October 17, 2012

RE: Engineering Review on the Eden Center

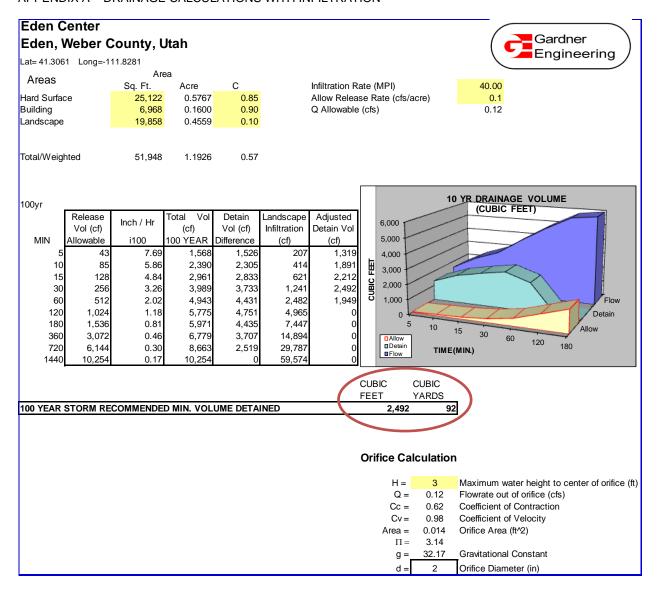
The attached exhibit illustrates the area in which the detention system was designed. As illustrated, the subject area includes the lot (38,869 SF) and the roadway (13,079 SF) for a total area of 51,948 SF.
